MIL-H-24606A(SH)
AMENDMENT 1
28 June 1991

MILITARY SPECIFICATION

HOSE ASSEMBLIES, CHLOROSULFONATED POLYETHYLENE IMPREGNATED, DOUBLE SYNTHETIC JACKET, WITH COUPLINGS, FIRE FIGHTING AND OTHER WATER SERVICE

Figure 1. Snap-Ring Groove and Snap Ring Details.

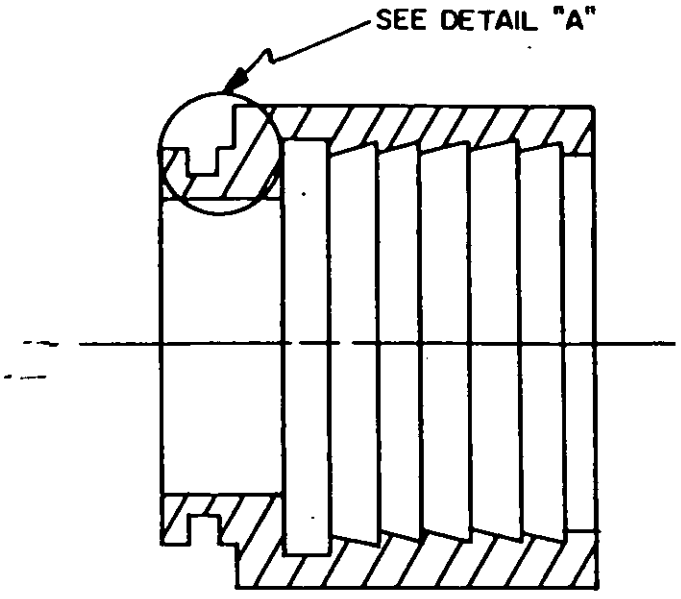
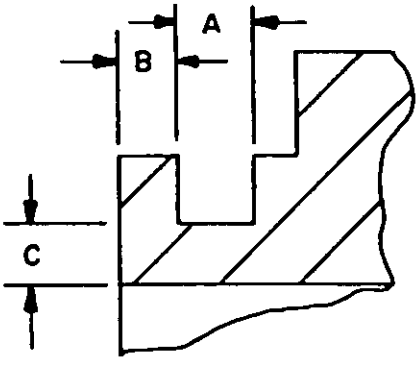
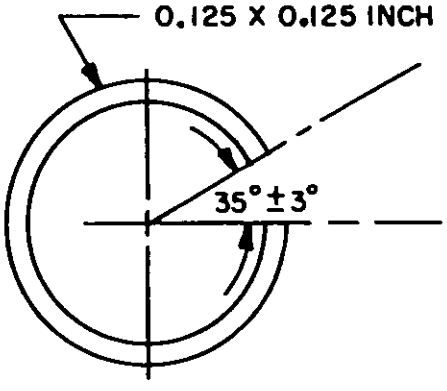
"3.3.6.1 Snap ring. Snap rings shall be fabricated of spring brass, alloy C26000 of ASTM B134. Snap rings shall be either square or rectangular. No other cross section is acceptable. Snap ring and snap ring groove dimensions shall be in accordance with Figure 1. Snap ring shall have a minimum of 50 percent engagement with the swivel."

Figure 1: Add as new Figure 1 (see Figure 1 on page 4 of this amendment).

Snap ring may be square or rectangular. No other cross section is acceptable. When assembled, the snap ring shall have a 50 to 60% engagement with the female swivel.

Snap ring must be flat to within 0.047 inch.
